Mayor Buist and City Council
Cc: Planning and Zoning Committee
Mendon City Corporation
15 North Main Street
Mendon, Utah 84325

**RE: Blueberry Springs Subdivision Preliminary Plat Submittal
Initial Engineering Review and Comments
*Revised for Clarification on Findings of Fact and Conditions***

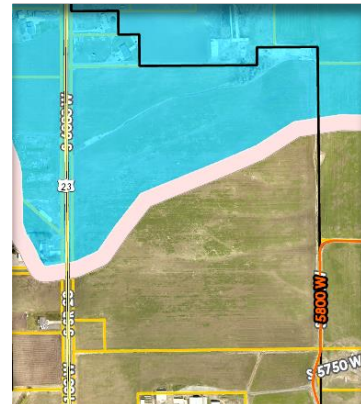
2. Reference Subdivision Code Section 3.12.B.12: The preliminary plat shall include the location of severely constraining elements such as...wetlands, watercourses, intermittent streams, one hundred (100) year floodplains, etc. The 100-year floodplain and its 100-foot buffer zone shown at right (<https://gis.cachecounty.org/>) was not identified, discussed, or addressed in the preliminary plat submittal. Nearly half of the subdivision parcel lies within the 100-year floodplain. The subdivision of land in or near floodplains involves the potential creation of tomorrow's flood risks. FEMA requires that all new subdivision proposals and other proposed development (including proposals for manufactured home parks and subdivisions) greater than 50 lots or 5 acres, whichever is the lesser, must include within such proposals, Base Flood Elevation data. The lowest floor of a residential building including basement must be above the Base Flood Elevation (BFE).

The applicant responded hereto and provided a Letter of Map Amendment which had been filed with FEMA in July of 2021 for the parcel which removed the property from the Special Flood Hazard Area with respect to the NFIP map. However, the applicant must file a floodplain development permit for construction of the stormwater pond and appurtenant conveyance systems which lie in Flood Zone A.

1. The applicant must file a floodplain development permit for construction of the stormwater pond and appurtenant conveyance systems which lie in Flood Zone A. (See FOF #2)
